A. DESCRIPTION OF THE PROPOSED CHANGE

This proposed amendment will revise Technical Specification Figures 3.1-3 and 3.1-4. These figures provide regulating group Control Element Assembly (CEA) insertion limits. Figure 3.1-3 provides CEA insertion limits when the Core Operating Limit Supervisory System (COLSS) is in service and Figure 3.1-4 provides the insertion limits when COLSS is out of service. The following two changes are proposed:

This proposed amendment will revise Technical Specification Figure 3.2-1A. This figure provides azimuthal power tilt limits versus core power for COLSS in service. The azimuthal power tilt limit will be increased for operation below 40% of rated thermal power.

This proposed amendment will revise Technical Specification Figures 3.2-2 and 3.2-2A. These figures provide DNBR margin limits for various configurations of COLSS and CEACs inoperable. The changes are necessary to ensure that the Technical Specifications are consistent with the safety analyses performed for the Cycle 3 core design.

FIGURE 3.1-4

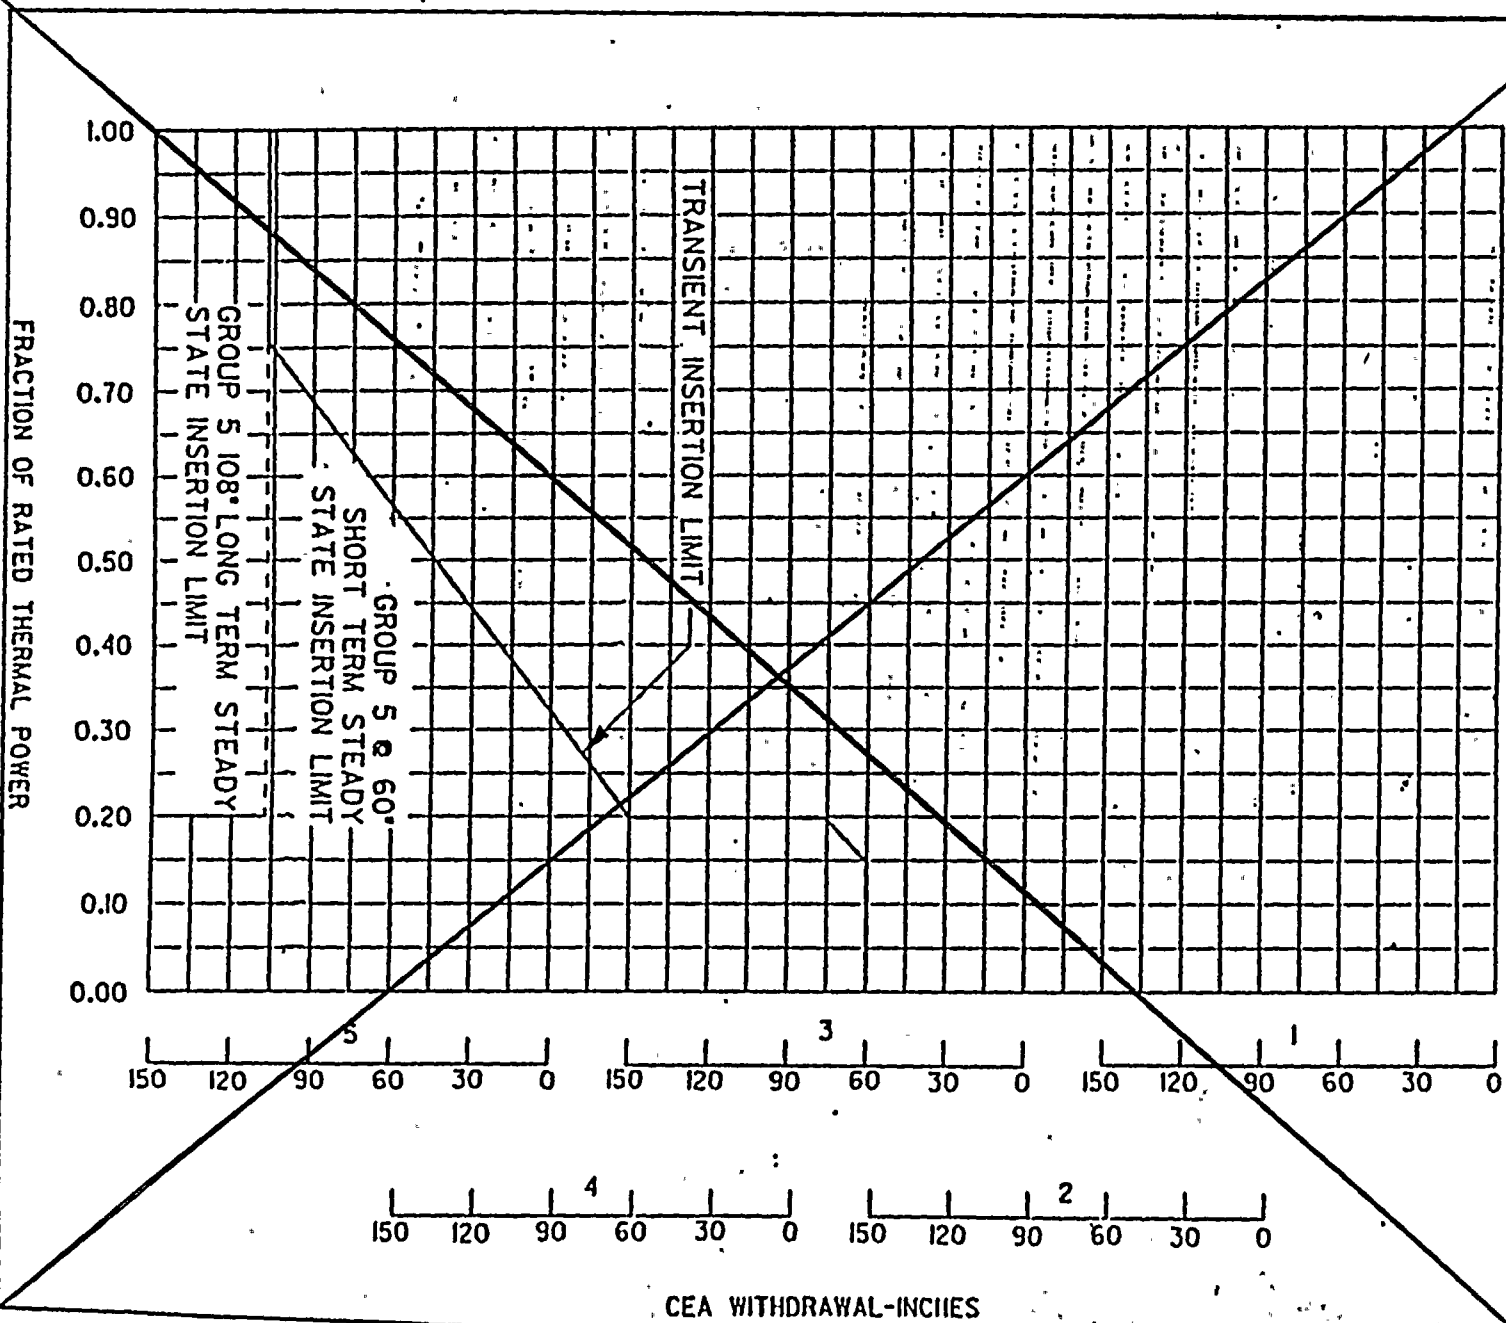
- i) The revised Figure 3.1-3 (COLSS in service) will not permit insertion of regulating group 3 CEAs above 20% of rated thermal power. This is more restrictive than the current specification which does allow for regulating group 3 insertion above 20% of rated thermal power.
- ii) The revised Figure 3.1-4 (COLSS out of service) will permit slightly increased insertion of regulating group 3 CEAs between 15% and 20% of rated thermal power.

REPLACE WITH
NEW FIGURE 3.1-4

The proposed changes to the transient insertion limits are necessary to ensure that the Technical Specifications are consistent with the safety analyses performed for the Cycle 3 core design. A more restrictive transient insertion limit line is required when COLSS is in service and a slightly less restrictive limit is allowed when COLSS is out of service.

FIGURE 3.2 - 1A
AZIMUTHAL POWER TILT LIMIT
VS
THERMAL POWER
(COLSS IN SERVICE)

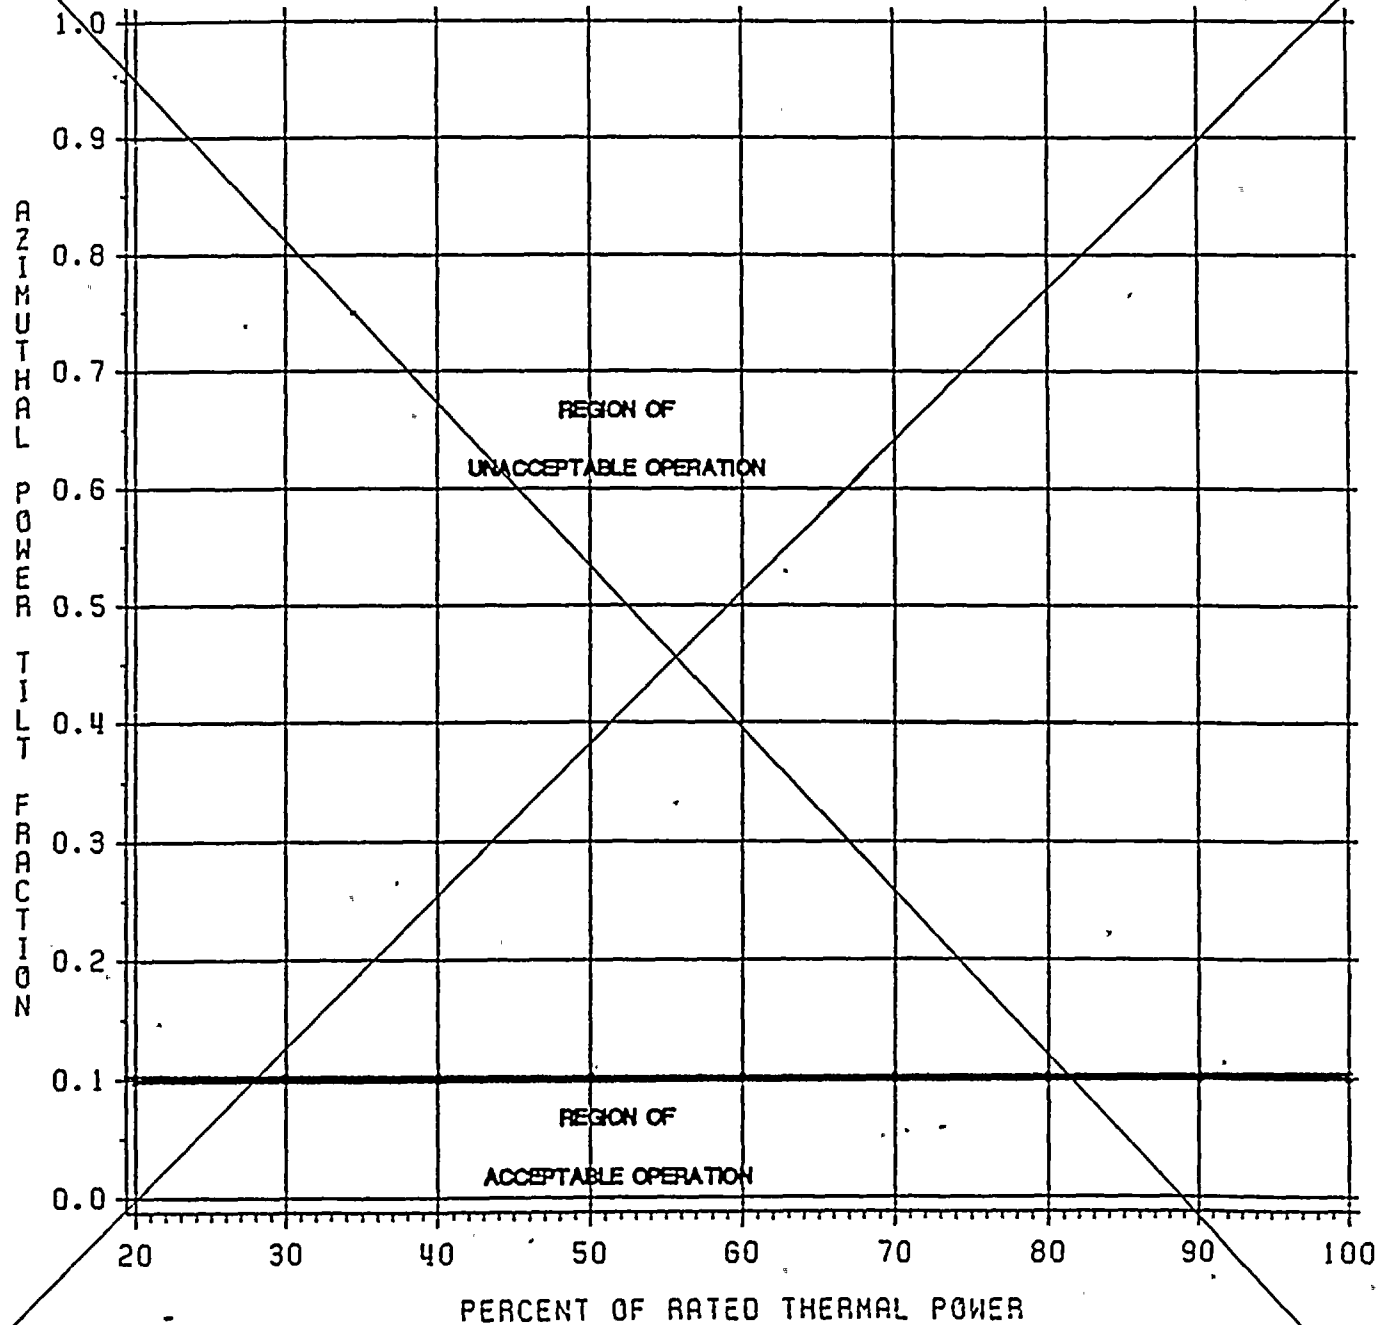
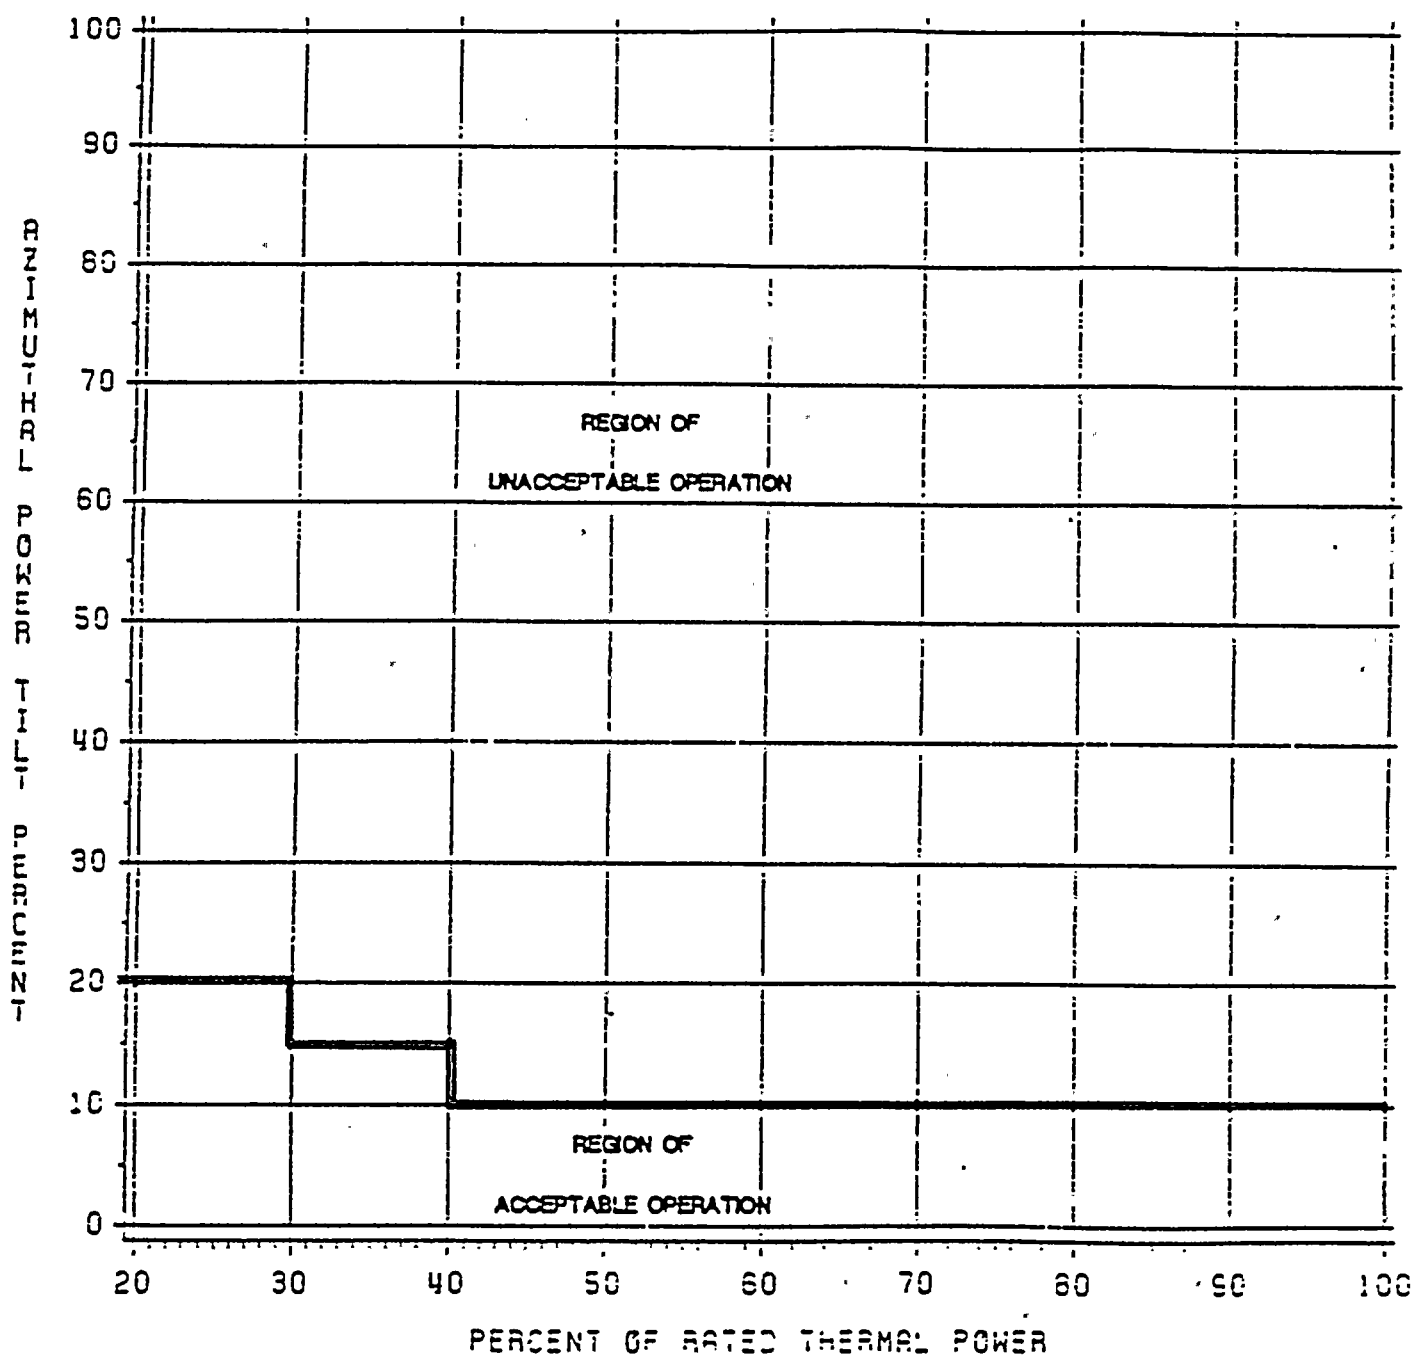
REPLACE WITH
NEW FIGURE 3.2-1A

Relaxation of the azimuthal power tilt limits with COLSS in service will allow the operators to better mitigate the consequences of xenon transients occurring below 40% of rated thermal power.

Physics calculations were performed to verify that the results of the Cycle 3 analysis, using the azimuthal power tilt limits proposed in Figure 3.2-1A with COLSS in service, were bounded by the reference cycle analysis. In particular, all events which use an explicit value for azimuthal power tilt in the calculation (i.e., the CEA ejection, single full length CEA withdrawal, and single part length CEA drop events) were reanalyzed with the new higher azimuthal power tilt limits. For the remaining DBEs, there is sufficient conservatism in the assumptions made for the initial conditions (from which the events are started) to account for the increased azimuthal power tilt allowed by the proposed Technical Specification change below 40% power. Above 40% power, the proposed figure is identical to the reference cycle and is therefore bounded by that analysis.
